BMAA – AIRCRAFT SERVICE BULLETIN

<i>Title:</i> Implementation of a new elevator friction device.	
<i>Reference:</i> SB MAAN 1877/2 issue 1 (Appendix A to MAAN 1877 issue 2)	<i>Applicability:</i> All Type Approved D, DD and D-SS aircraft.
<i>Issue date:</i> 20 June 2005	
Mandatory modification to aircraft	
This SB must be incorporated before the first flight after 20 June 2005

Figure 1, Elevator teleflex cable rear end and horn attachment

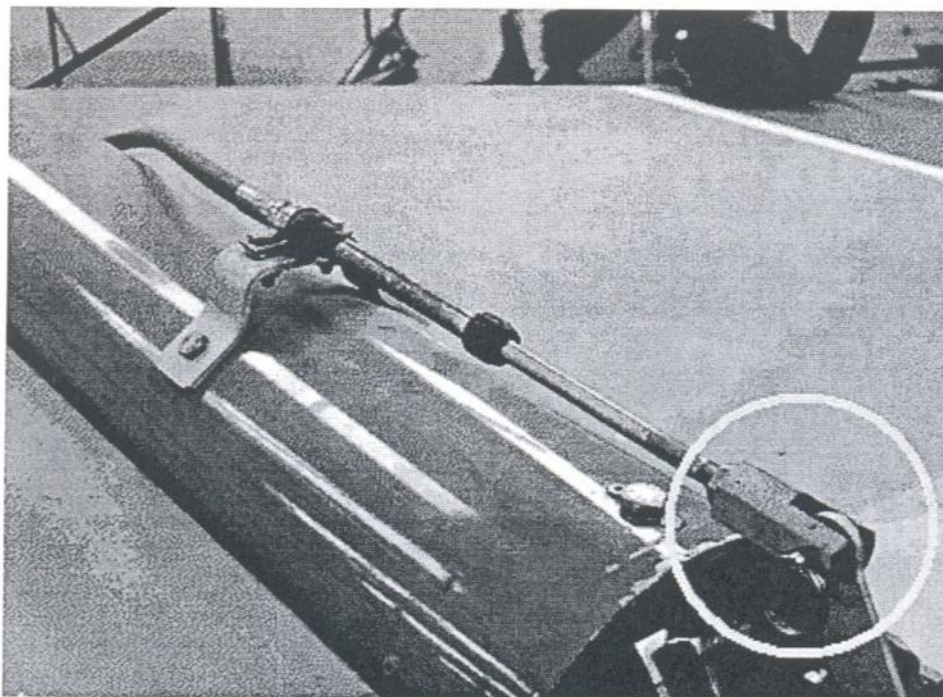
- (A) Carefully loosen or disassemble the elevator damper mechanism, smear all bearing surfaces with a thin layer of grease, re-assemble in the original order.
- (B) Disconnect the elevator Teleflex cable by removing the single pin and clevis ring at the top elevator horn (see Figure 1 below)

Figure 2, damper in place with vertical bolt refitted.

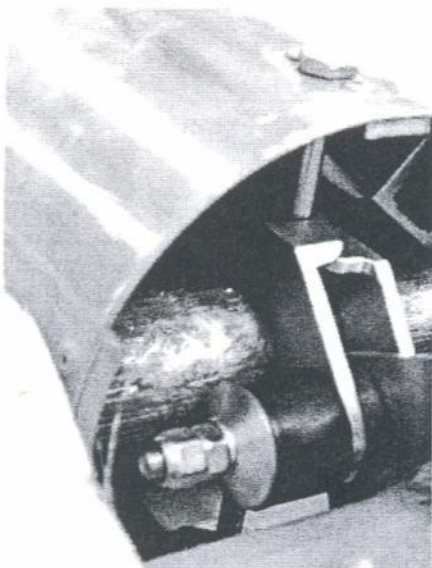
- (G) Take the new elevator damper unit and place it so that the side with two brackets is around the fixed tail plane trailing edge spar with the hole through the trailing edge spar tube (see Figure 2 & Figure 3 below) [Note: photo below shows the elevator fitted, this is not how you should see it.]. **NOTE:** the damper rotating arm is vertically handed to match the elevator horn and that the assembly has a horizontal offset arranged by odd thickness friction washers to ensure that the rotating arm lines up with the horn when assembled and ready to be drilled/fitted.

- (H) Push the tail plane trailing edge vertical locating bolt back through the boom tube from the top so that it goes through. Refit the safety pin at the bottom (see Figure 3 below, elevator stop omitted for clarity).

Figure 4, Re-fitted teleflex attachment with damper in place

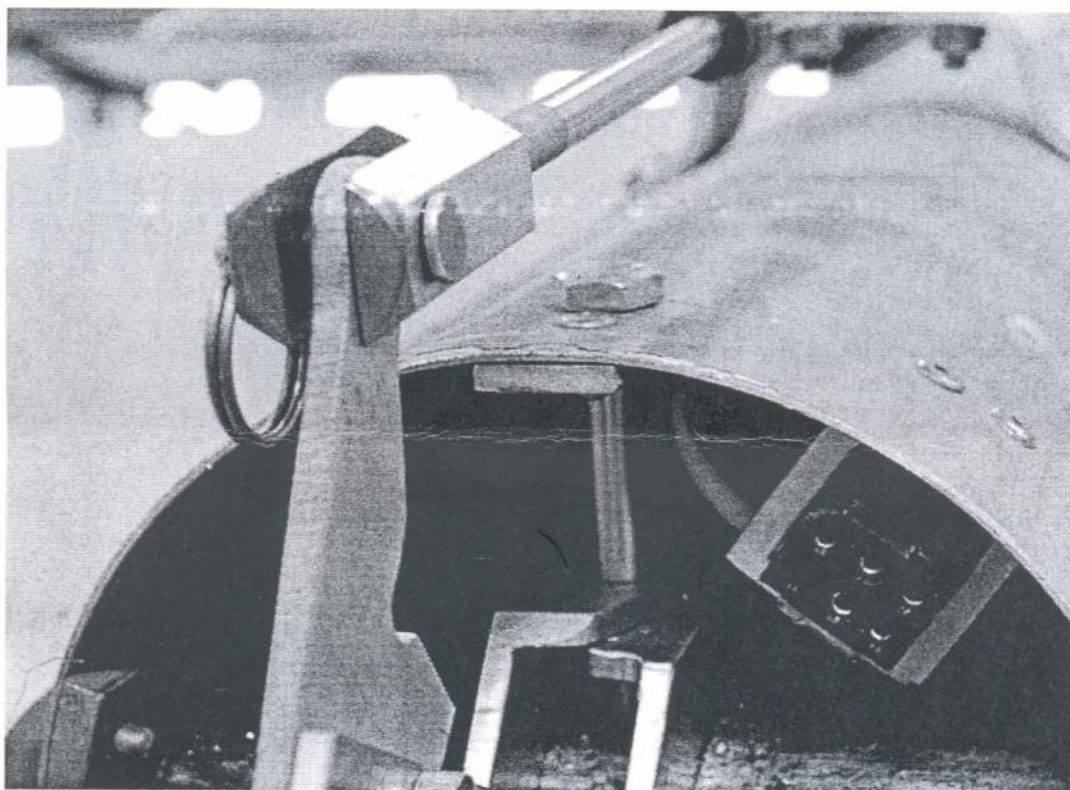
- (I) Refit the elevator, taking care to reconnect QTY4 elevator hinge pins (including their safety pins), then re-attach the elevator Teleflex attachment and clevis ring (see Figure 4 below).

Figure 6, Fully assembled parts at rear of fuse tube.

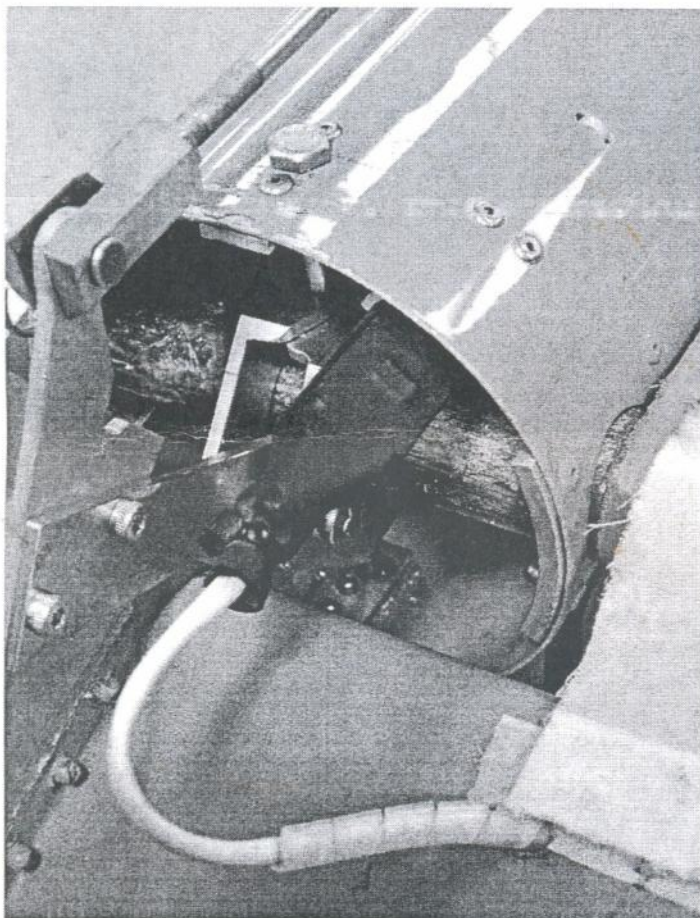
- (L) Repeat this process for the underside arms. (Note: if available, it is permissible to add a drop of “loctite blue” or similar thread locking compound to the screws and nuts during fitting.
- (M) Re-attach elevator trim tab electrical connector plug and socket (see Figure 6 below)

Figure 7, Making adjustments to the damper mechanism,

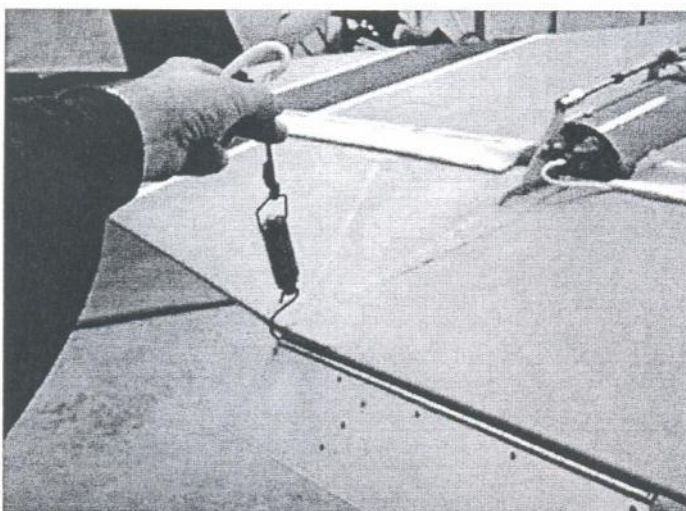
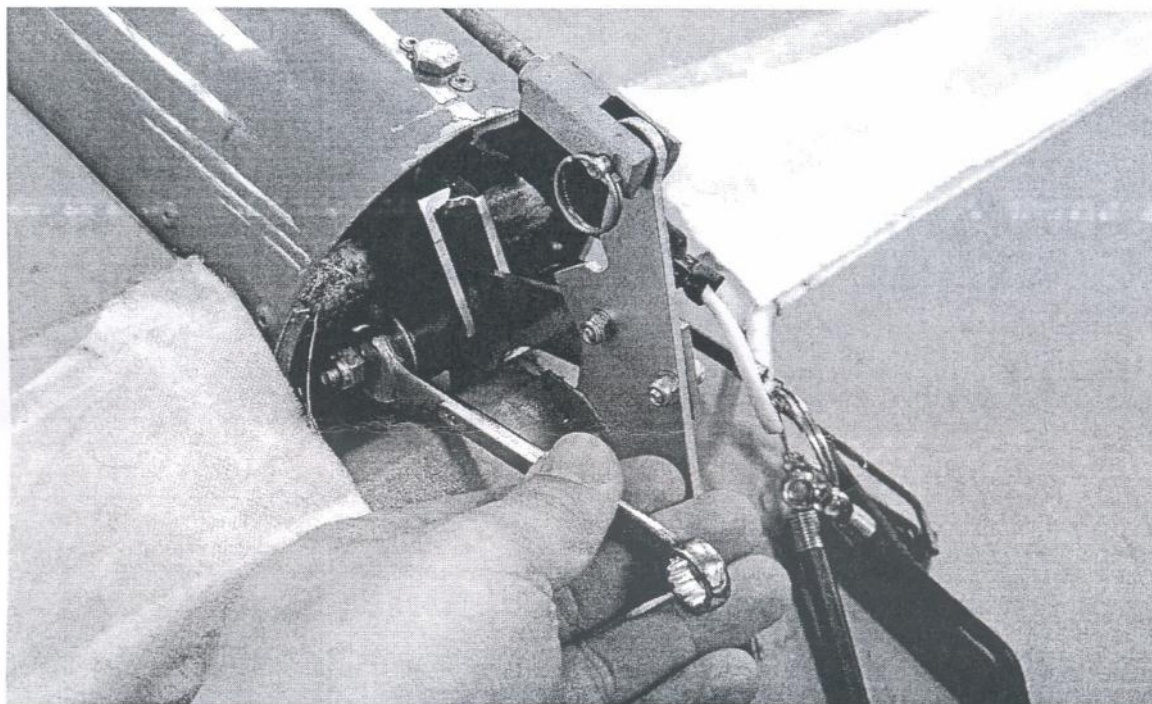
- (N) Now adjust the friction on the device using a 10mm open-end spanner and Allen key (see photo) so that with the elevator horizontal, you need 2.5 - 2.6 kg [5.5 – 5.7 lbf] of pull upwards (at the trailing edge of the elevator centreline, next to the trim tab hinge) to move the elevator. After the correct adjustment is found tighten the 6mm nylock locking nut against the aduster nut to secure. (Figure 7 below.)
